RE: Rochester Housing Authority,  
**Atlantic Townhouse Roof Replacement**

**ADDENDUM #1**

**Rochester Housing Authority  
Atlantic Ave. Townhouses – Roof Replacement  
HUNT 2285-015**

**ADDENDUM No. 1**

**1 RIDGE VENT DETAIL**  
 3" = 1'-0"

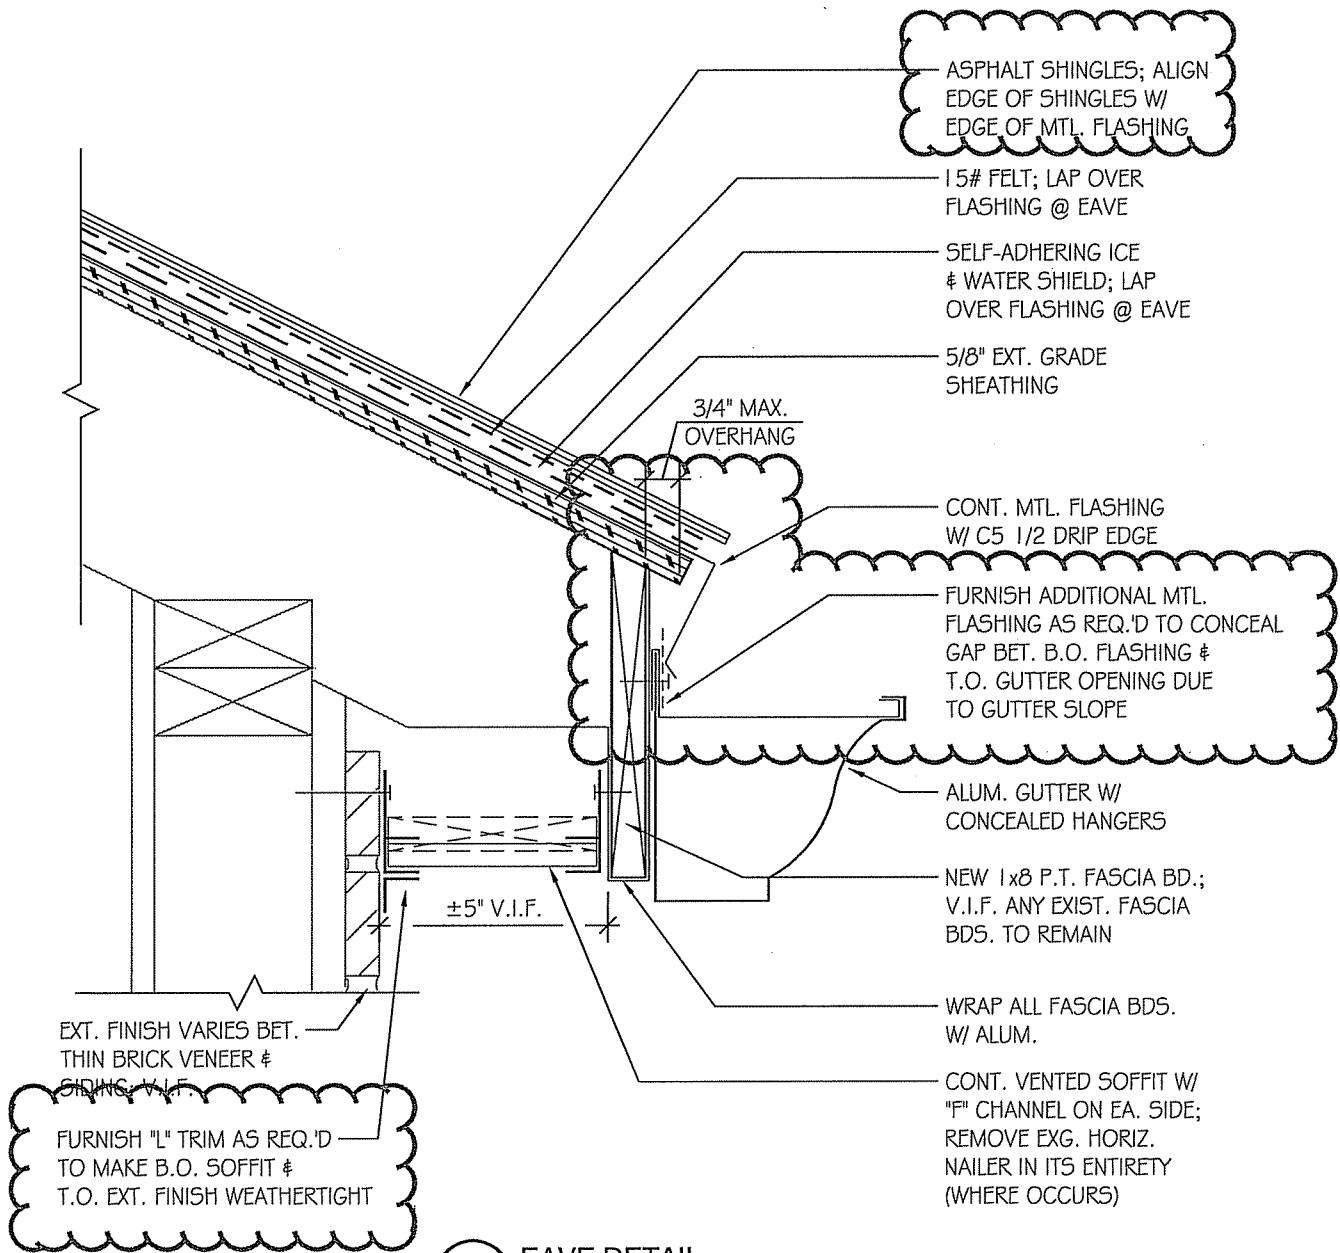
**Amend** detail 1/A1.3 with detail shown on AD-A1.  
**Amend** detail 2/A1.3 with detail shown on AD-A2.  
**Amend** detail 5/A1.3 with detail shown on AD-A3.

NOTE: CONTRACTOR SHALL INSTALL RIDGE VENT AS PER MANUFACTURER'S INSTRUCTIONS; SILICONE CAULK MAY NOT BE REQUIRED.

**2 EAVE DETAIL**  
3"=1'-0"

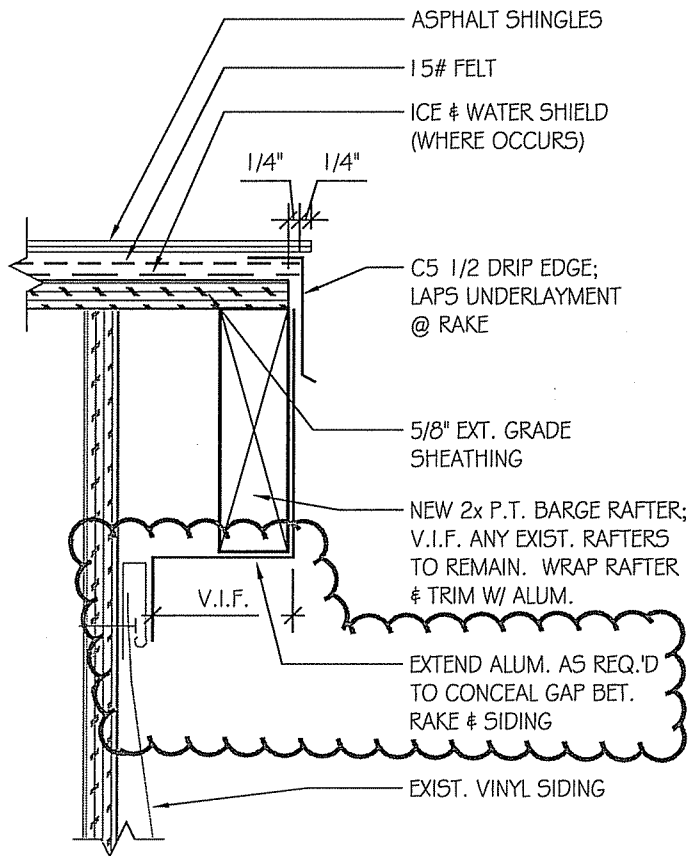
**A:** All existing caps shall be replaced as required to install new collars.
8. **Q:** In the Side Eave Detail, it shows the exterior grade sheeting almost flush with the fascia board. This could pose a problem as the metal depicted in the drawing will be in the gutter on one end of the roof and not the other when the gutters are pitched properly. Should the sheeting be extended 3/4 inch past the fascia board and use F5 drip metal instead of C51/2?

**A:** Refer to AD-A2 for a revised detail.
9. **Q:** This question may not pertain to you, but maybe you can help clarify it. I noticed on page 1 or 9 of the labor rates section the "Construction Type" is stated as Residential. Is this correct?

1. CONTRACTOR SHALL VERIFY EXISTING EAVE ASSEMBLY AFTER DEMOLITION & PRIOR TO INSTALLING NEW WORK.
2. CONTRACTOR IS RESPONSIBLE FOR ENSURING ROOF EDGE IS CONTINUOUSLY FLASHED INTO THE GUTTER.
